ORDINANCE NO. 2017-39

AN ORDINANCE OF THE CITY OF WYLIE, TEXAS, REPEALING ORDINANCE NO. 2012-38; ADOPTING THE 2015 EDITION OF THE INTERNATIONAL RESIDENTIAL CODE, SAVE AND EXCEPT THE DELETIONS AND AMENDMENTS SET FORTH HEREIN; PROVIDING FOR A PENALTY FOR THE VIOLATION OF THIS ORDINANCE; PROVIDING FOR REPEALING, SAVINGS AND SEVERABILITY CLAUSES; PROVIDING FOR AN EFFECTIVE DATE OF THIS ORDINANCE; AND PROVIDING FOR THE PUBLICATION OF THE CAPTION HEREOF.

Recommended Amendments to the 2015 International Residential Code North Central Texas Council of Governments Region

****Figure R602.6.1; delete the figure and insert the following figure:**

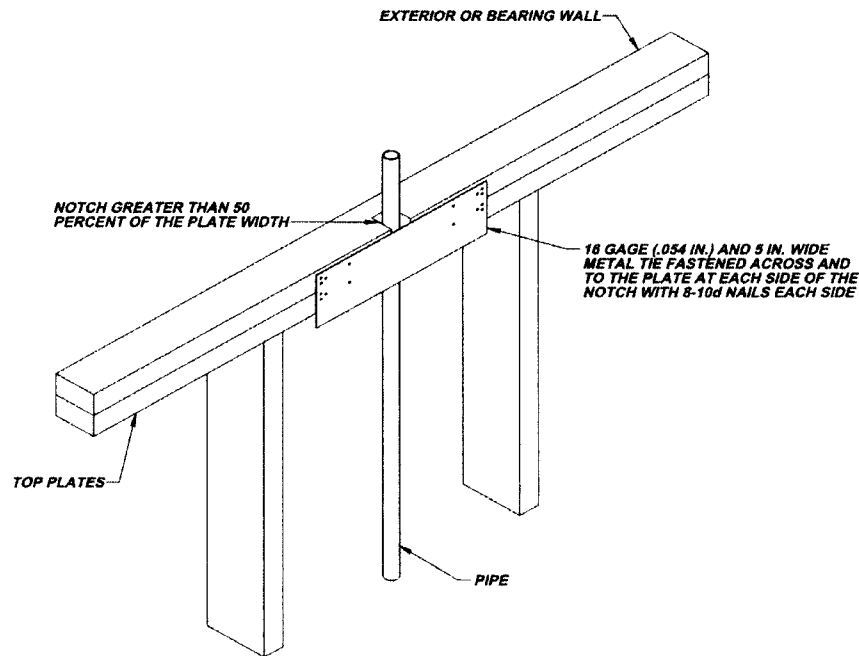
R602.6.1 Drilling and notching of top plate. When piping or ductwork is placed in or partly in an exterior wall or interior load-bearing wall, necessitating cutting, drilling or notching of the top plate by more than 50 percent of its width, a galvanized metal tie not less than 0.054 inch thick (1.37 mm) (16 Ga) and 5 inches (127 mm) wide shall be fastened across and to the plate at each side of the opening with not less than eight 10d (0.148 inch diameter) having a minimum length of 1 ½ inches (38 mm) at each side or equivalent. Fasteners will be offset to prevent splitting of the top plate material. The metal tie must extend a minimum of 6 inches past the opening. See figure R602.6.1. *{remainder unchanged}*

(Amendment to 2012 IRC carried forward to 2015 IRC also provides additional assurance of maintaining the integrity of the framing by spreading the nailing pattern.)
